Figures and Text Withheld Under 10 CFR 2.390

Chapter 1 General Information

Figure 3-1
Canister Finite Element Model

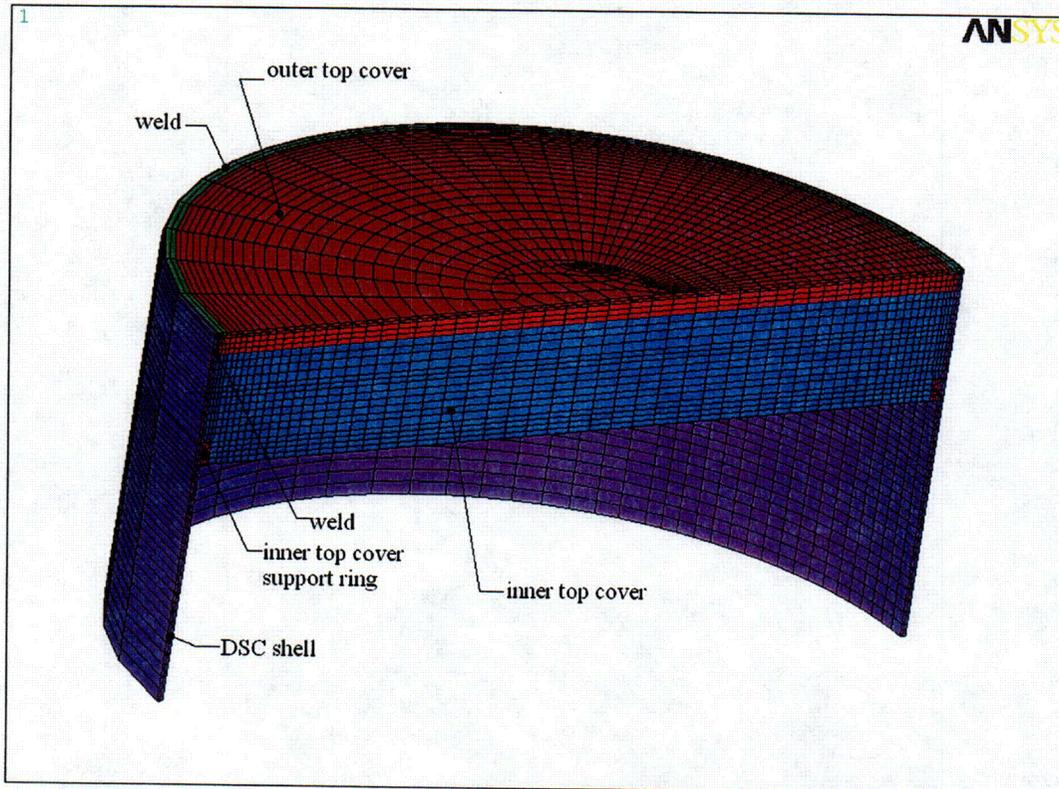
3-3 Justify in Appendix 3.9,1, Table 3.9.1-7, why the allowable stress intensities for the end closure welds were based on the material tensile stress, when the end closure welds are partial penetration welds and the allowable stresses should be based on the material shearing stresses. In addition, on page 3.9.1-55, Lifting Block Weld Stresses, allowable stresses appear to be based on the material yield stresses when it should be revised to be based on the shearing stresses.

The 3D canister finite element model as described in Appendix 3.9.1, Section 3.9.1.3.2, page 3.9.1-40) is used for calculating the canister corner drop. The finite element model is shown on Figure 3-1.

Figure 3-11
32PTH Basket with SS Rails

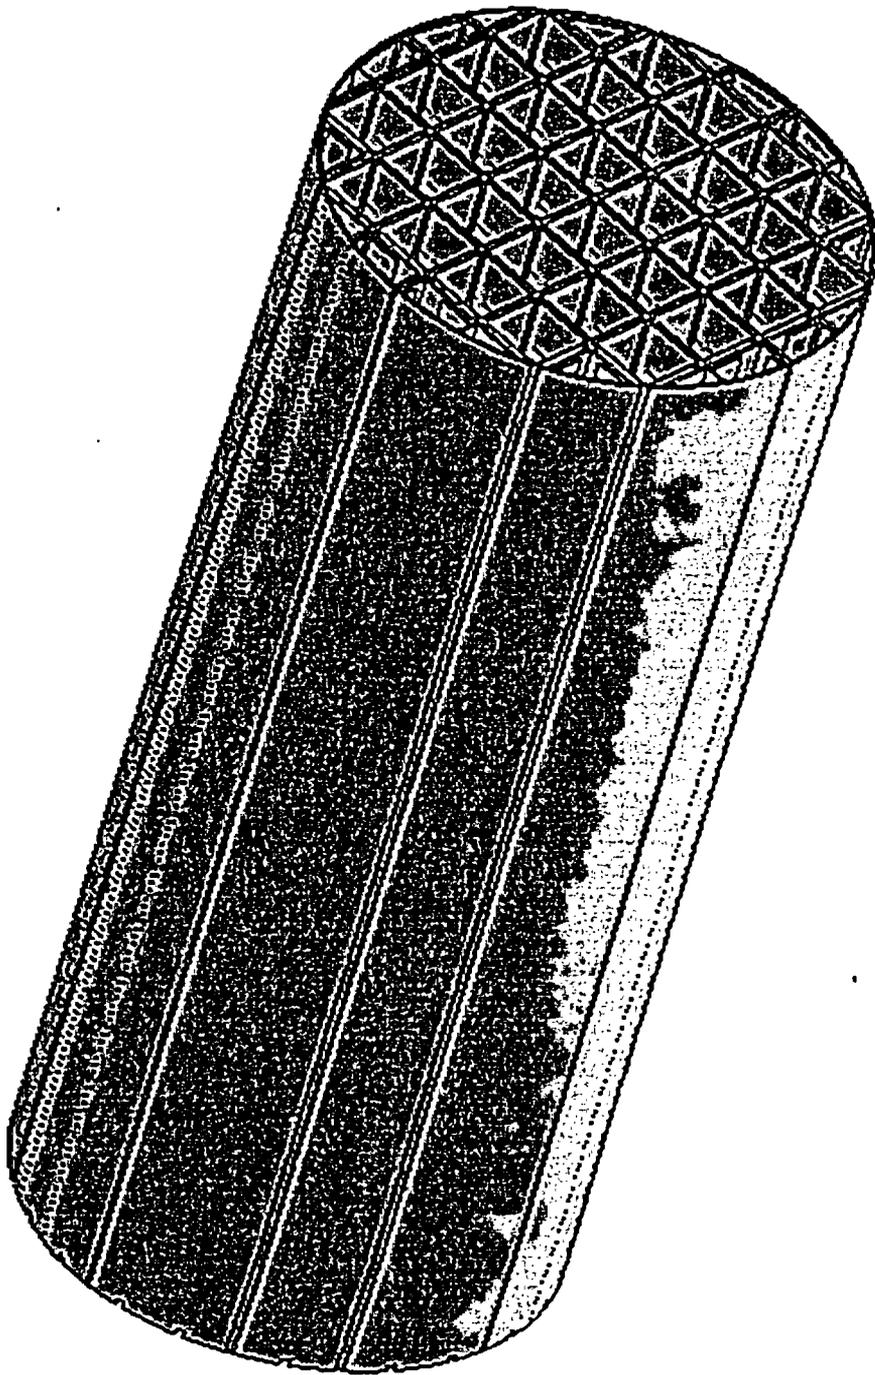
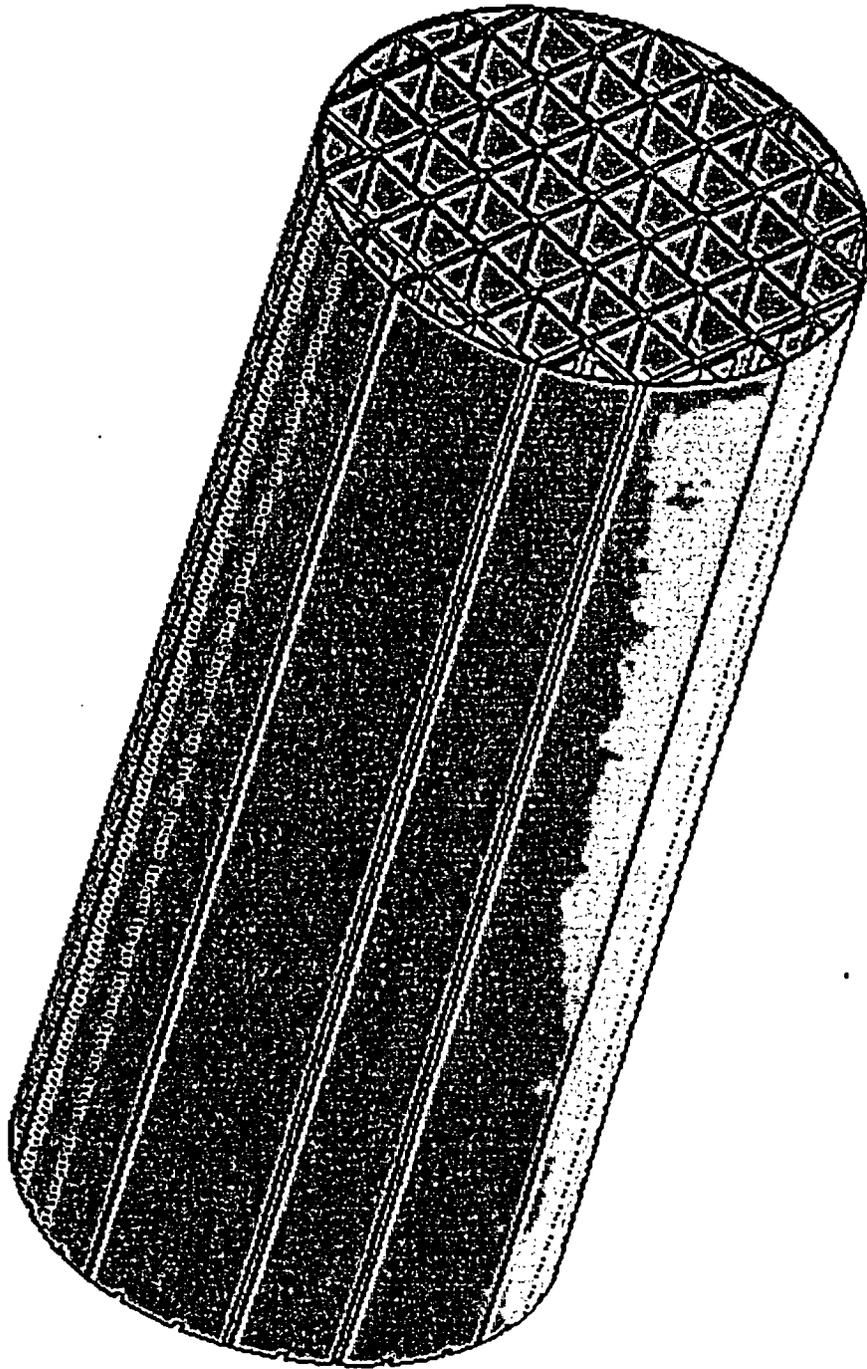
- 3-4 The collapse load approach to evaluate buckling loads of 32PTH DSC fuel basket plates and support rails is not acceptable (See Chapter 3, RAI 1). Given the fact that the fuel basket plate supports are fusion welded to the stainless steel fuel compartments, it is not clear why a small three-dimensional ANSYS finite element model is needed to calculate the buckling load., (Section 3.7.1,1 2) In addition, the drawing shows the basket plates are aluminum (B209) not SA-240 Type 304 stainless steel. However, the application stated that a buckling analysis of the full size basket was conducted for a 45degree azimuth basket orientation drop (Page 3.9.1-29).. The inelastic finite element analysis converged up to a load of 86,,4g. The design g-load is 75g and thus the safety factor is approximately 86.4g/75g=1.15. Please justify that this small safety factor is adequate to**

prevent buckling of the basket components during a 75g side drop of the transfer cask. Confirm that the buckling analysis was performed based on the correct materials and material properties.

Stainless steel rails are oriented parallel to the axis of the canister and attached to the periphery of the basket to establish and maintain basket orientation and to support the basket. Figure 3-11 of this RAI shows the entire basket assembly with stainless rail.

Figure 3-17
Lateral Force Exerted on Inner Shell (Transfer Cask Top End Drop)

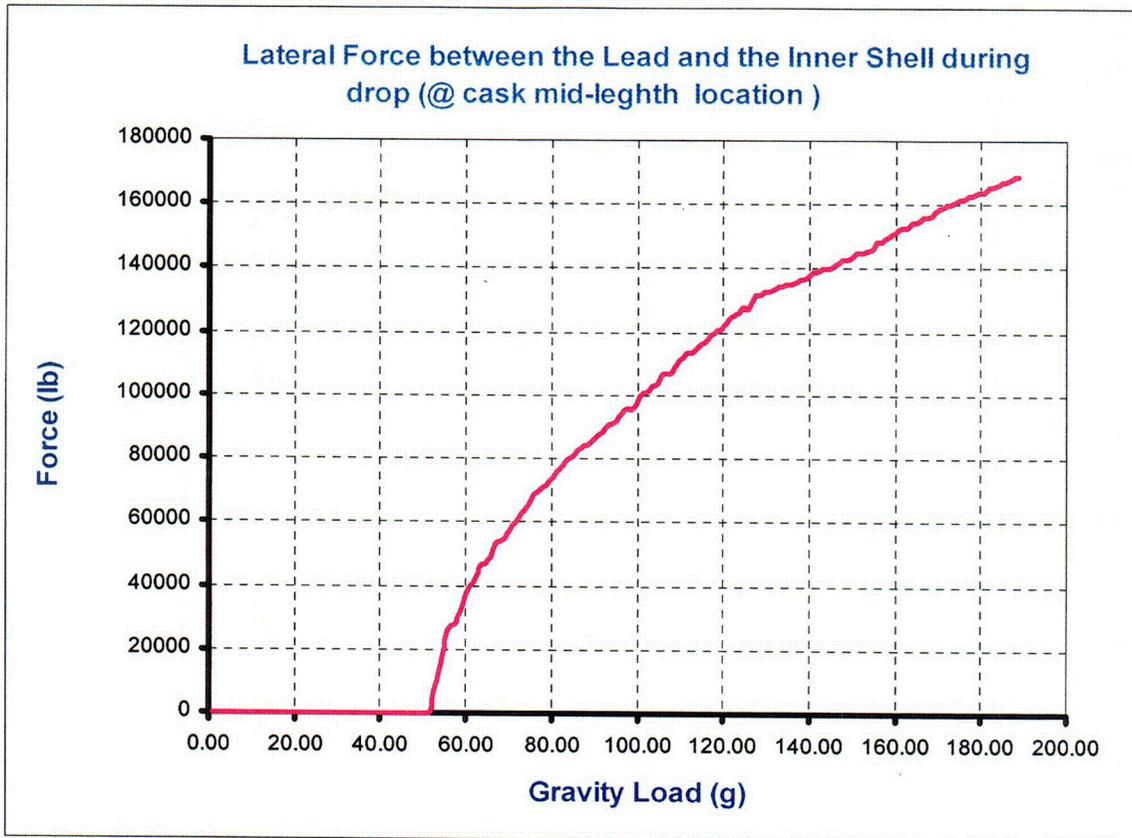
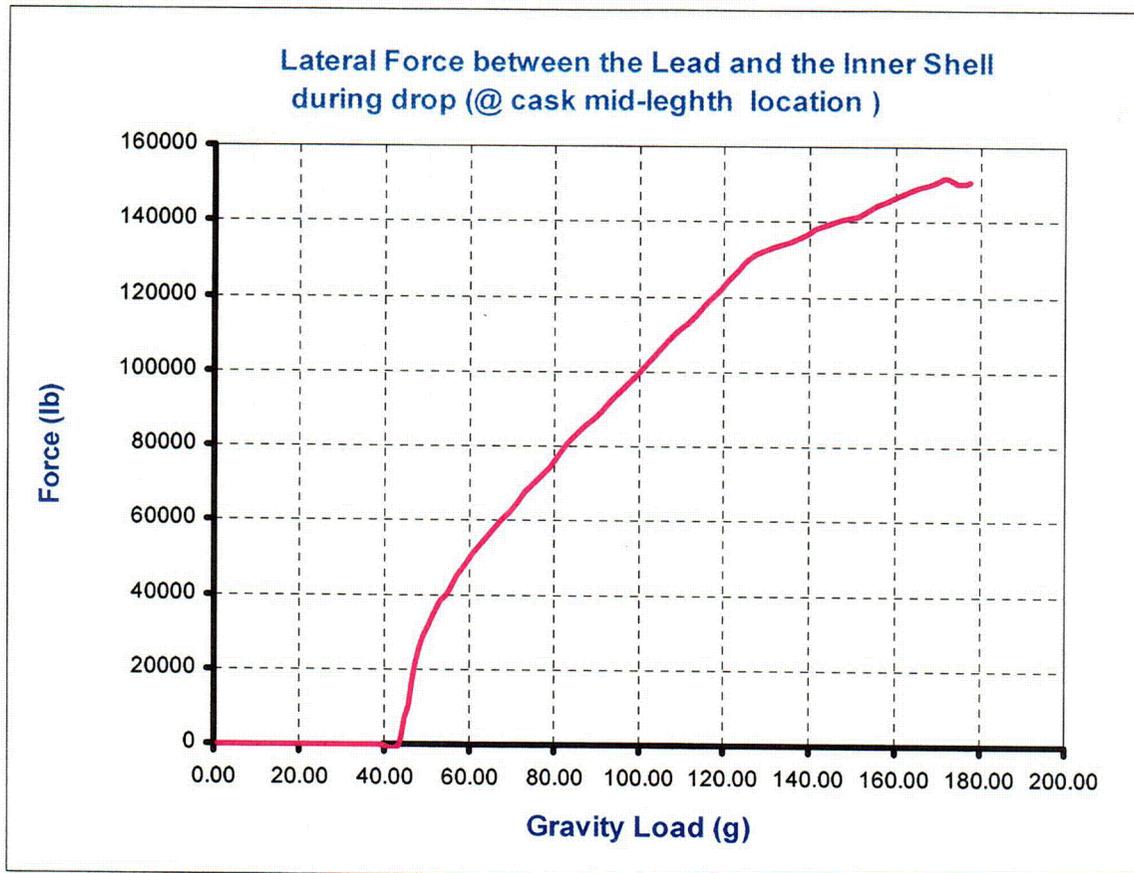
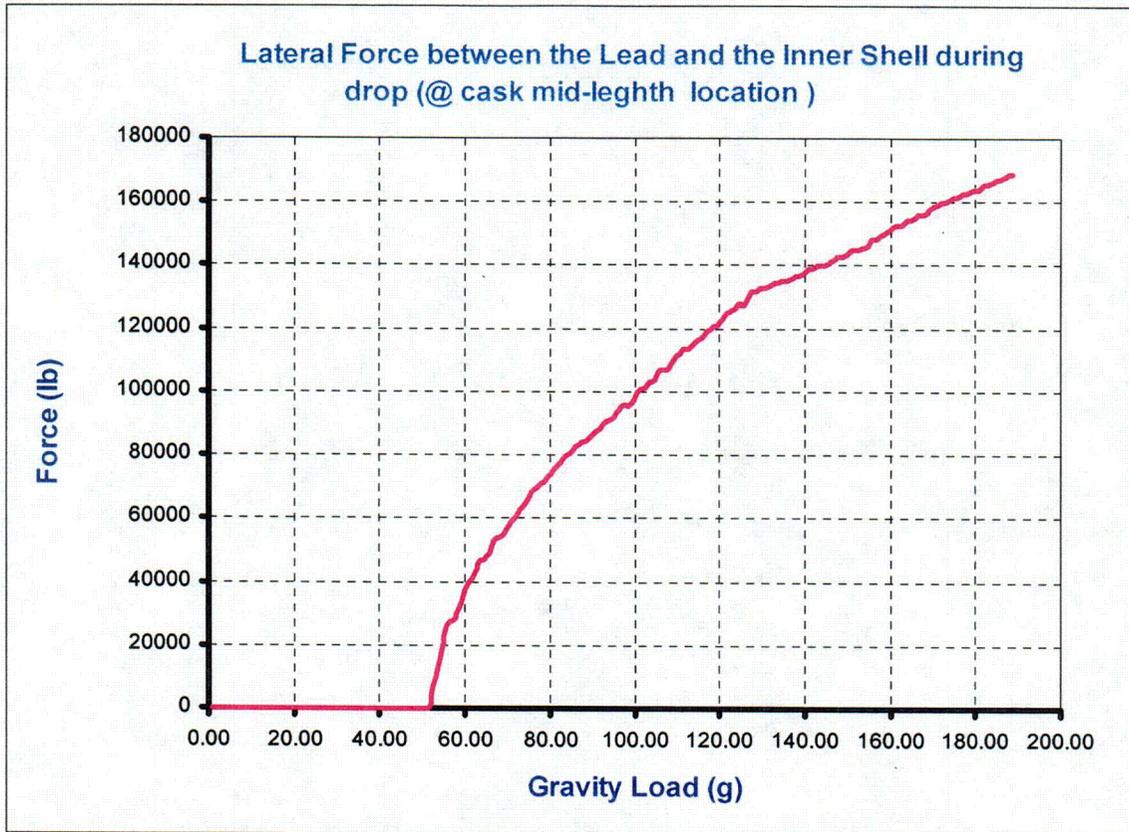
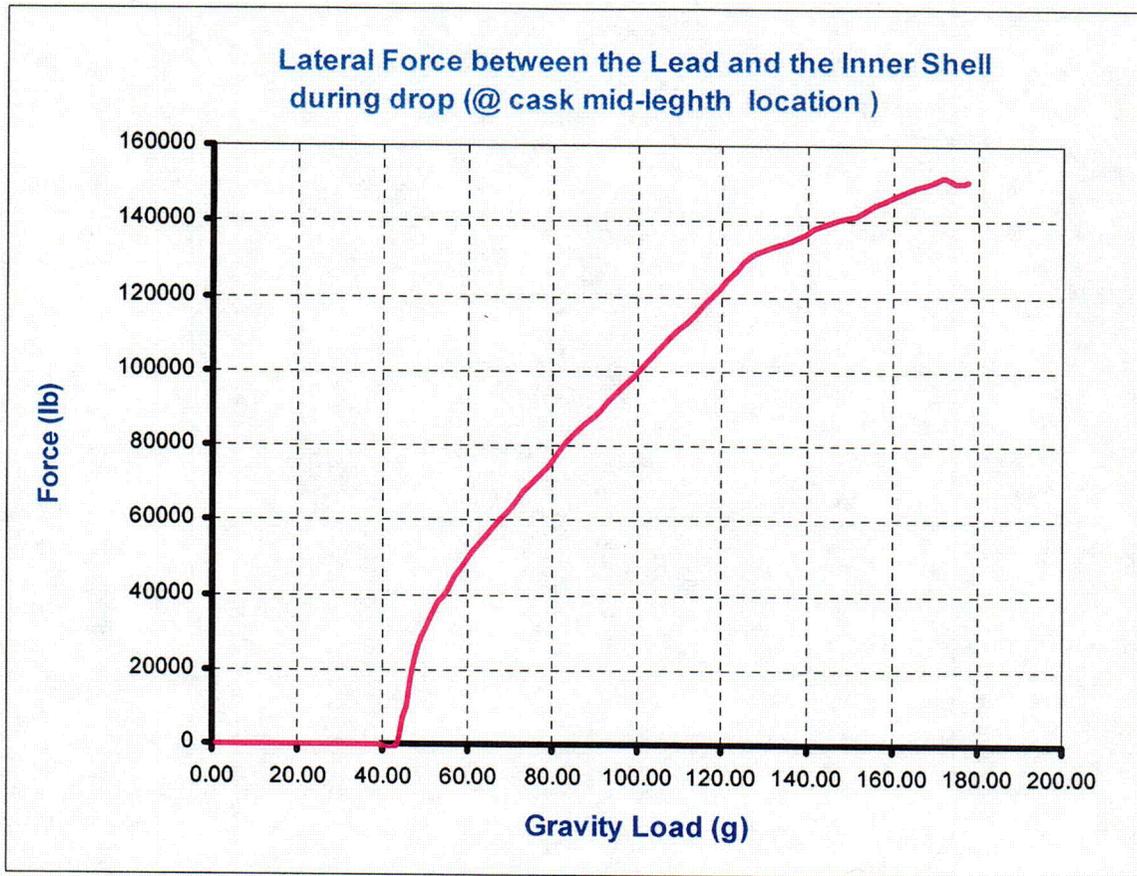
3-5 Provide justification for a concurrent 30 psig internal pressure in the evaluation of the structural adequacy of the OS187H Transfer Cask inner shell with respect to buckling.

The lateral pressure of the lead vs. g load at a typical location in the middle section of the cask during the top and bottom end drops are shown in Figures 3-17 and 3-18, respectively. These figures show that the pressure load increases as the g load increases.

Figure 3-19
Transfer Cask Inner Shell & Flange Weld Details

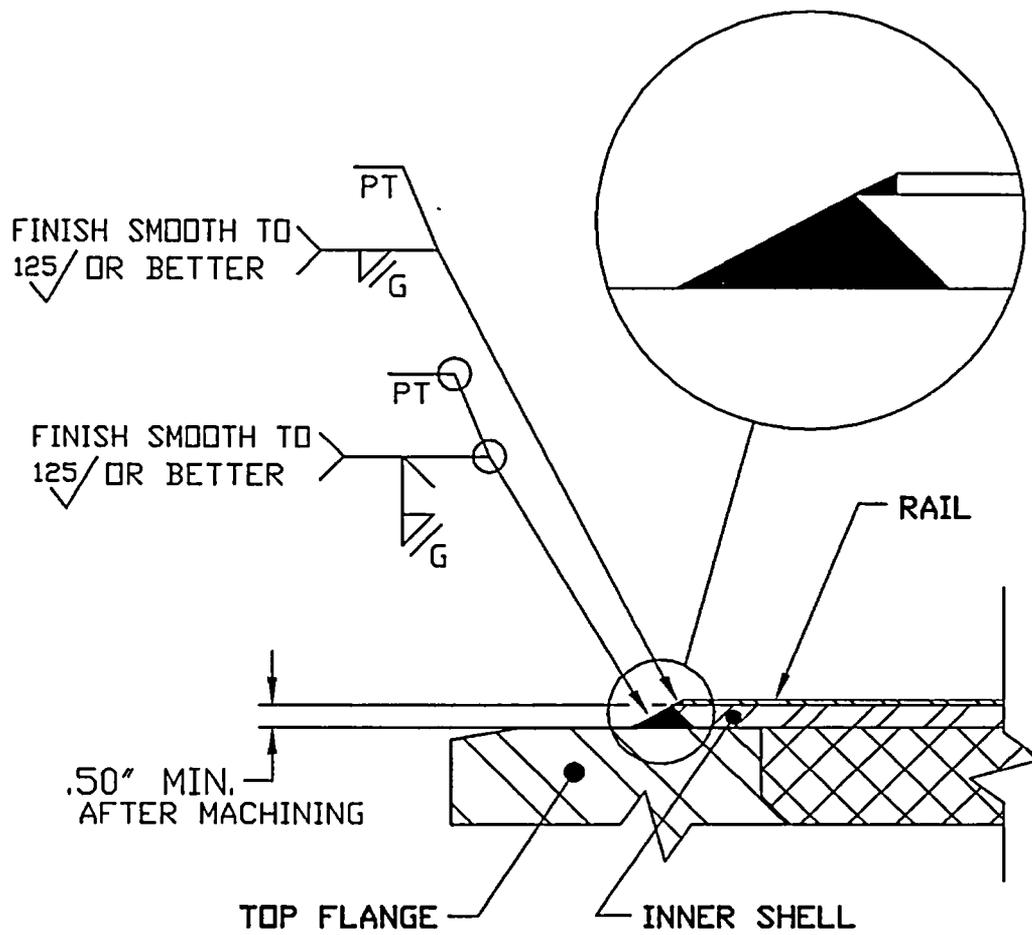
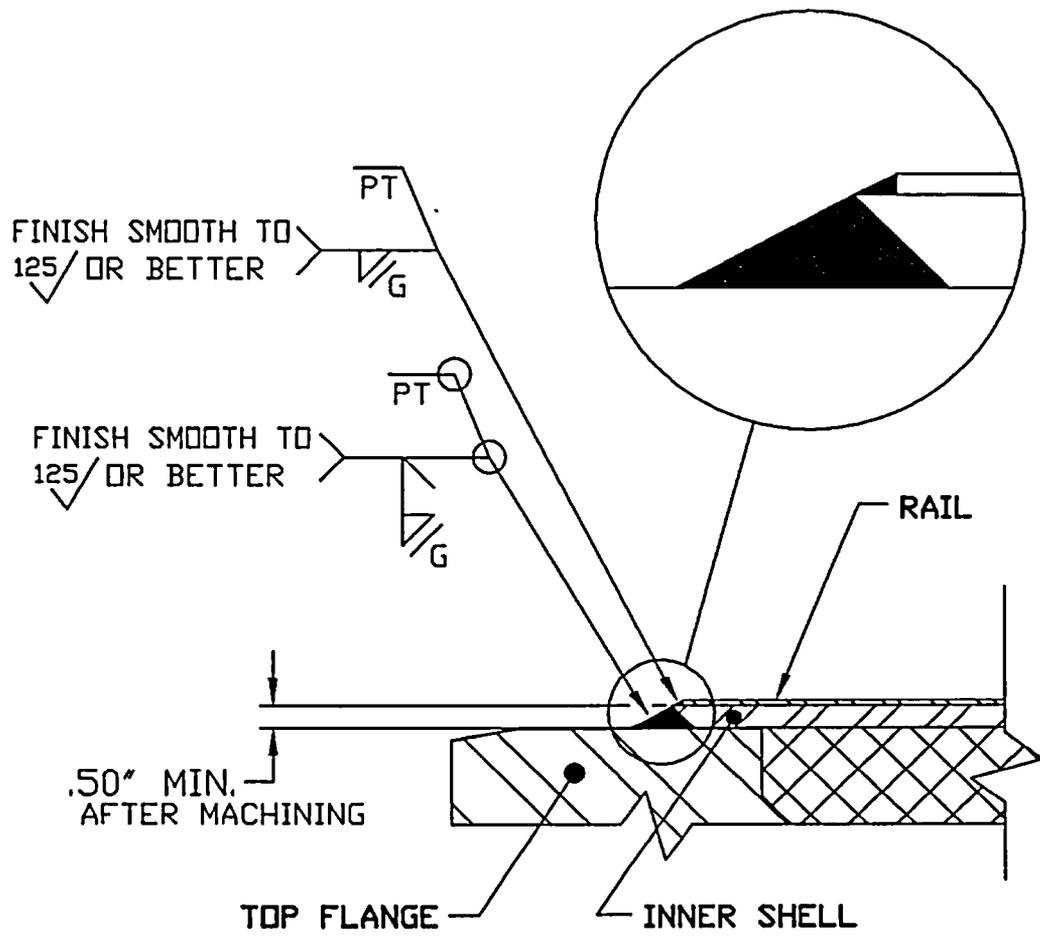
3-7 Perform a top end corner drop dynamic impact structural analysis of the transfer' cask to show the adequacies of the top inner shell weld to the top forging.

The inner shell is attached to the top flange (forging) by fillet welds (Drawing No, 10494-72-19)., It is unclear whether the welds have adequate strength to prevent separation of the inner shell from the top flange for a top end corner drop of the transfer cask.

The inner shell is full penetration welded to the transfer cask bottom plate (see TN drawing 10494-72-19, right side of inner shell assembly view) and also full penetration welded to the transfer cask top flange (left side of the inner shell assembly view). In addition to the full penetration welded to the flange a fillet weld is added to the joint. An enlarge detail of this weld is shown on Figure 3-19 for information. Both weld symbols are called out on the drawing.
